ND-10-0964

Southern Nuclear Operating Company
Vogtle Electric Generating Plant Units 3 and 4
Site Safety Analysis Report License Amendment Request
Revise Backfill Geometry

**Vogtle Electric Generating Plant Units 3 and 4
Site Safety Analysis Report License Amendment Request
Revised Backfill Geometry**

SSAR Markup

Figure 2.5.2-71 Comparison of SASSI 2D Bathtub NI Model SSI Responses:
Node 4041-EL 99 NI at Reactor Vessel Support Elevation

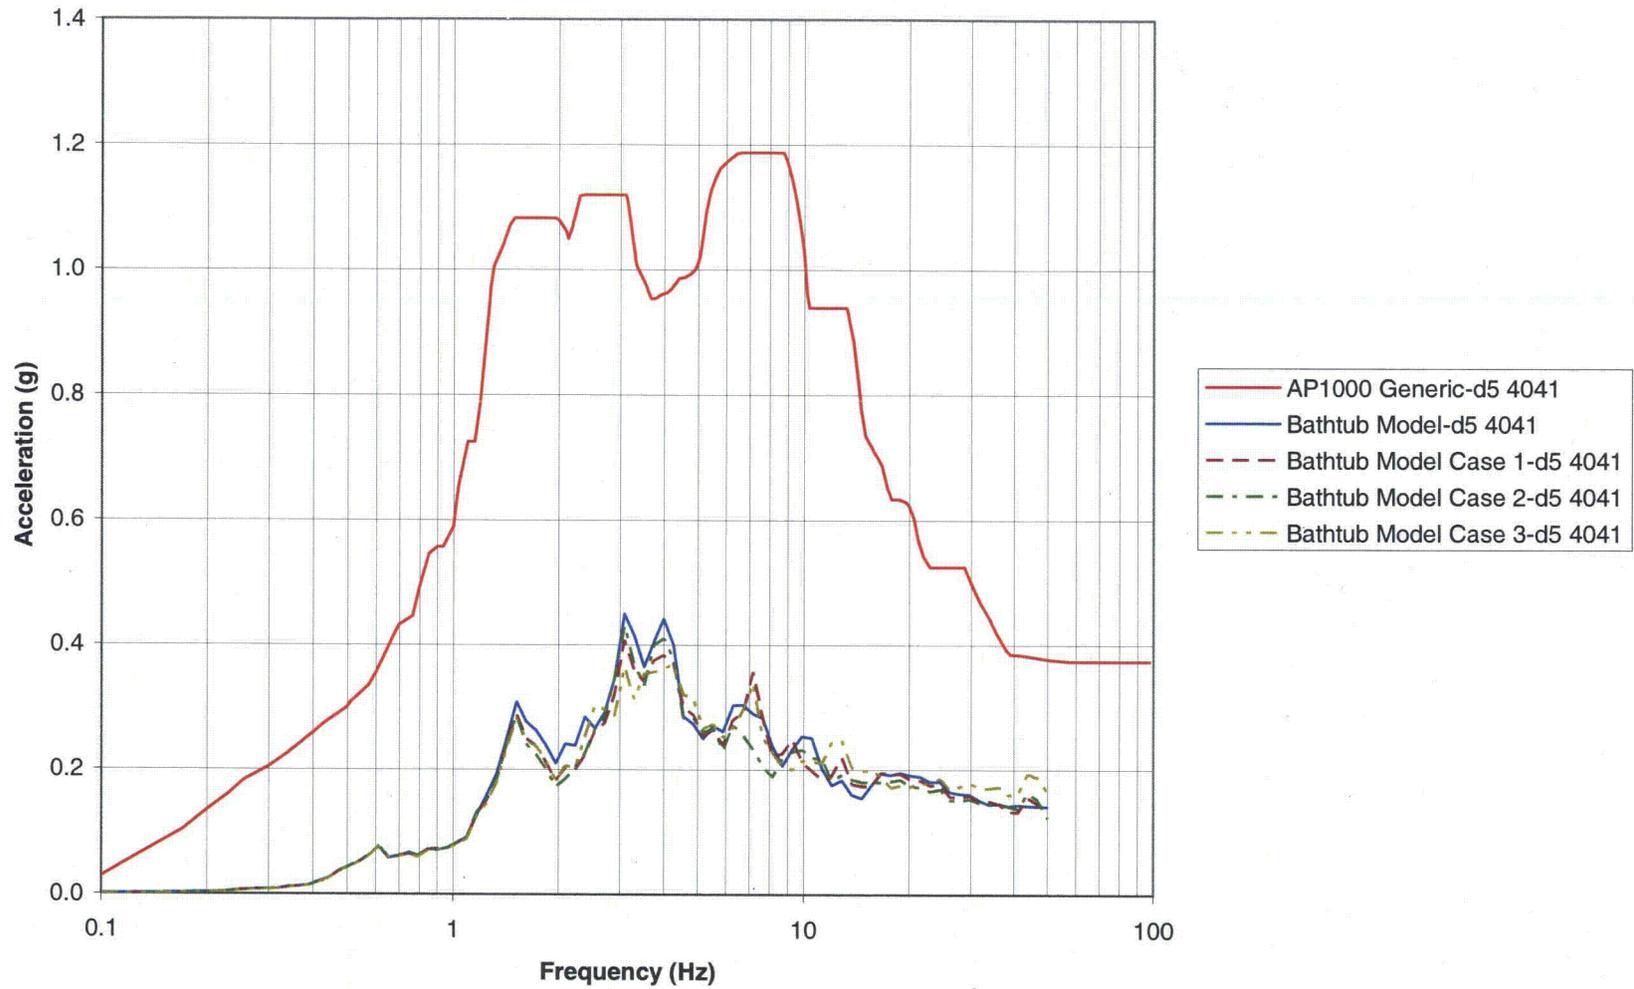
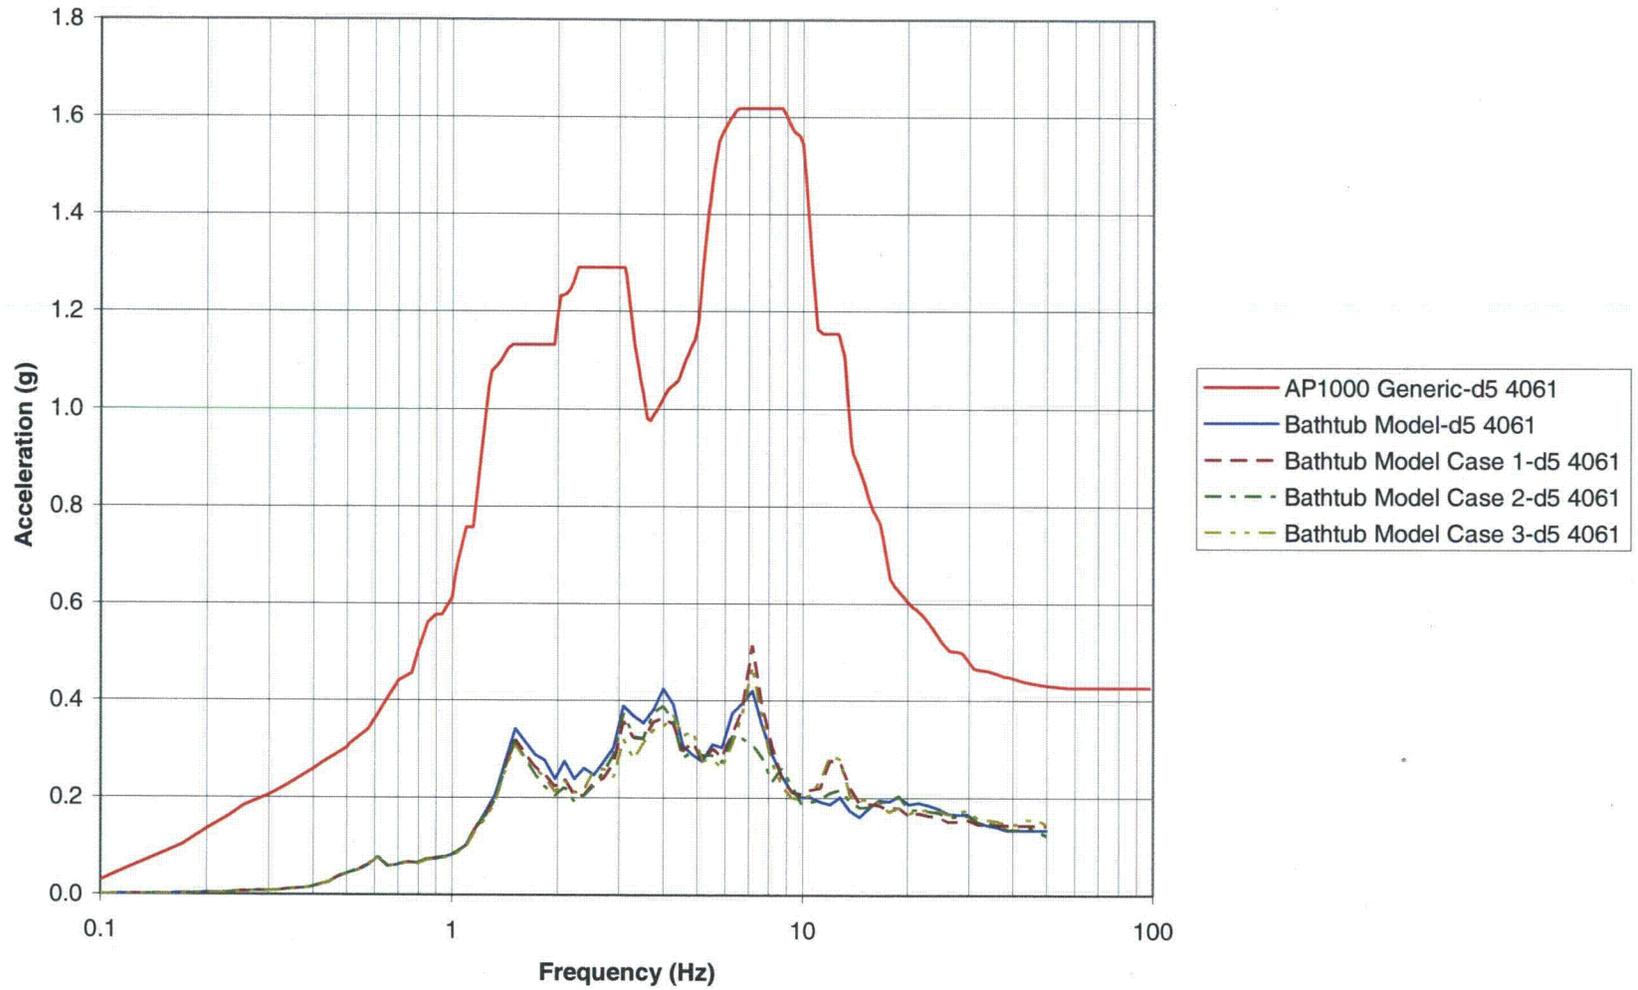
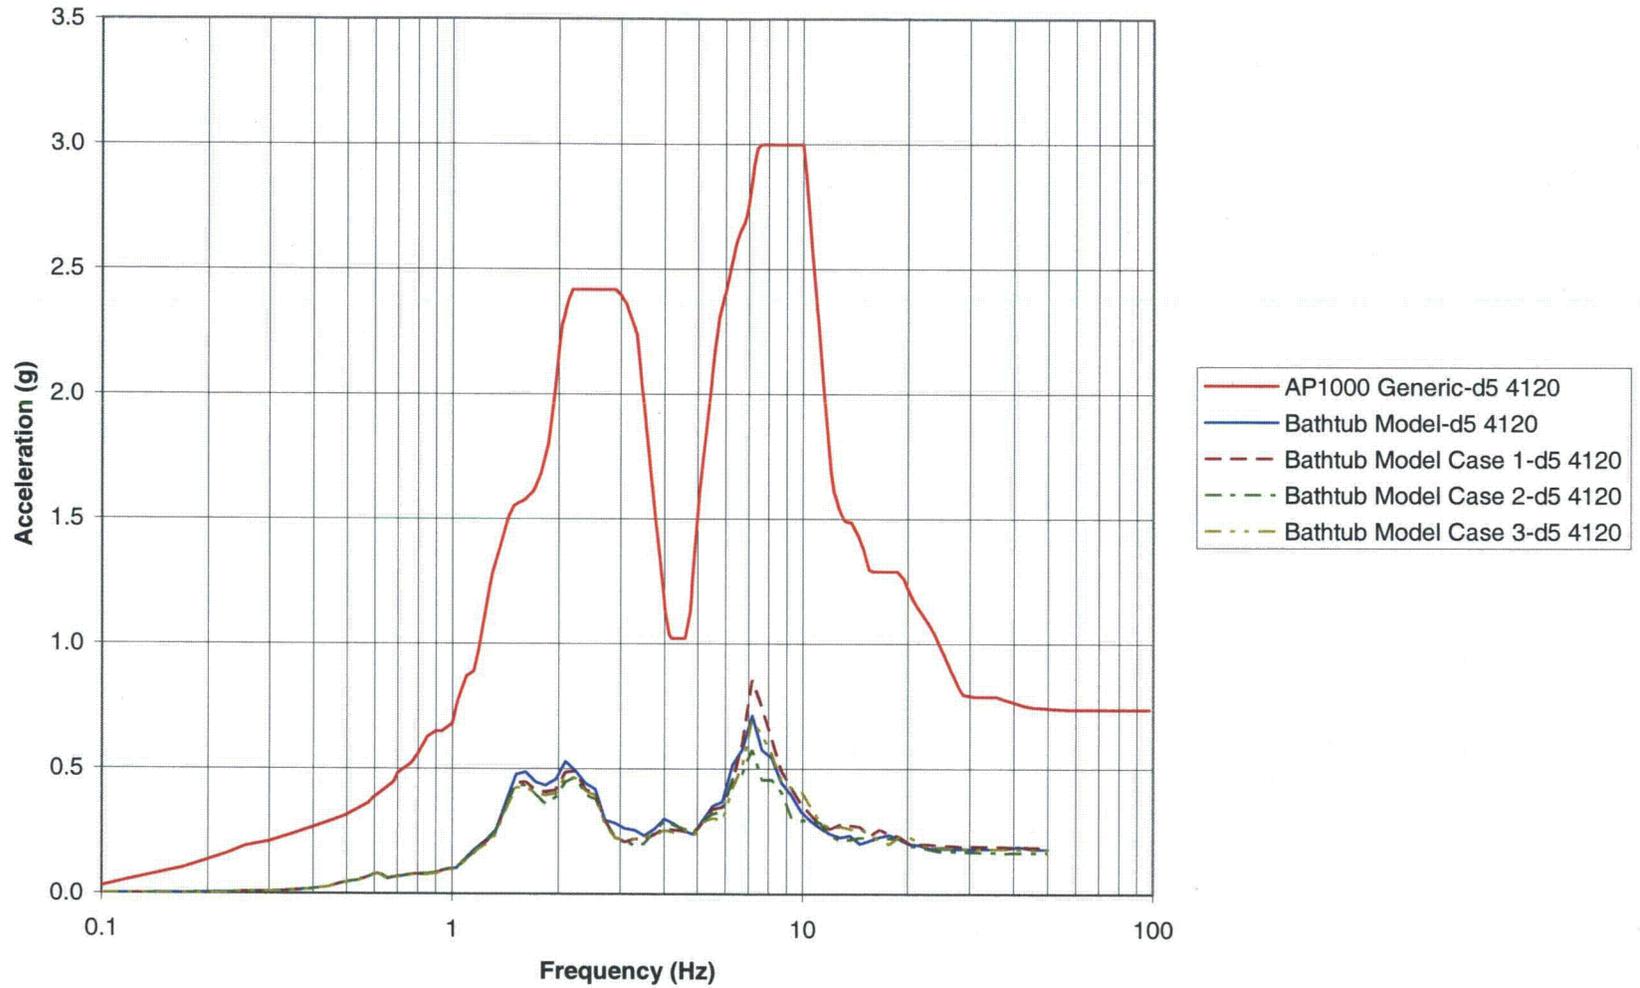
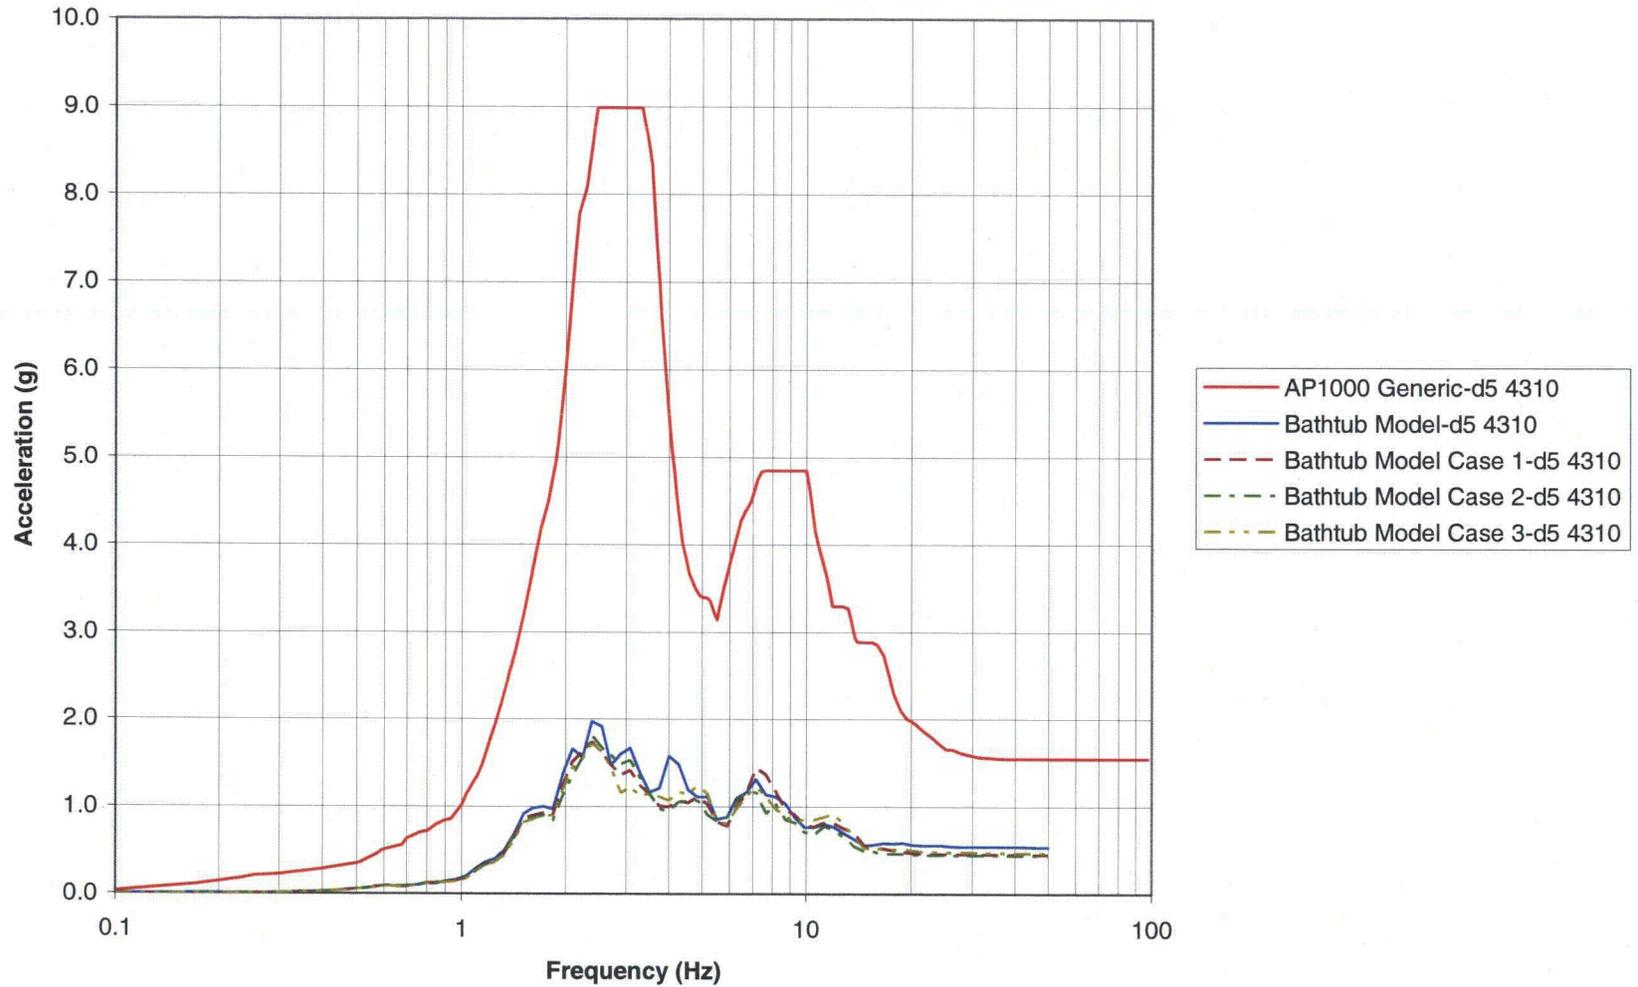
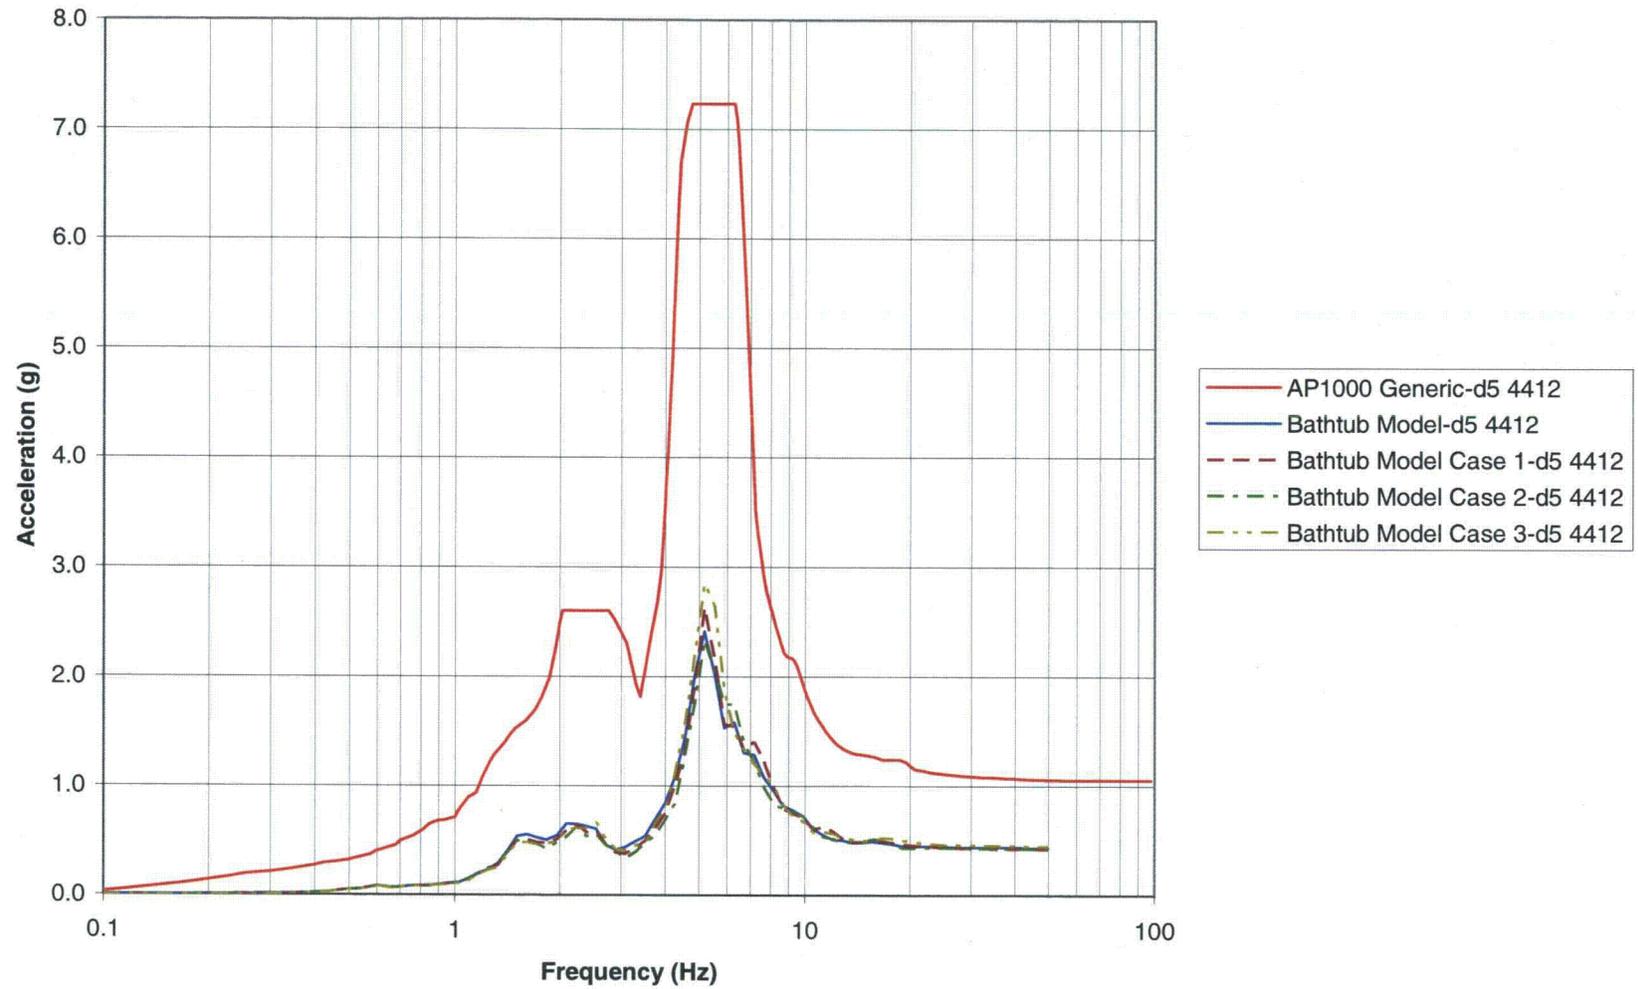
Part II of 2.5.2.9.2 provides the sensitivity study for site seismic SSI analyses. The same 2D SASSI SSI bathtub model shown in Figure 2.5.2-58 was used here except the material over the slopes was changed. Three cases described above were considered, the results of cases 1, 2, and 3 are compared to the 2D SASSI SSI bathtub results of 2.5.2.9.2. These results are the horizontal in-structure response spectra at the six key locations in the NI and are shown on Figures 2.5.2-71 through 2.5.2-76. The 2D SASSI SSI bathtub results of 2.5.2.9.2 with the Best Estimate Category 1 and 2 backfill properties used throughout the excavation are identified as "Bathtub Model-d5." The generic AP1000 standard 2D design response spectra are plotted for comparison purposes as was done in 2.5.2.9.2. As shown in these figures the differences are very small confirming that backfill with shear wave velocities lower and higher than Category 1 and 2 backfill can be placed over the slopes without invalidating the results and conclusions provided in 2.5.2.9.2.
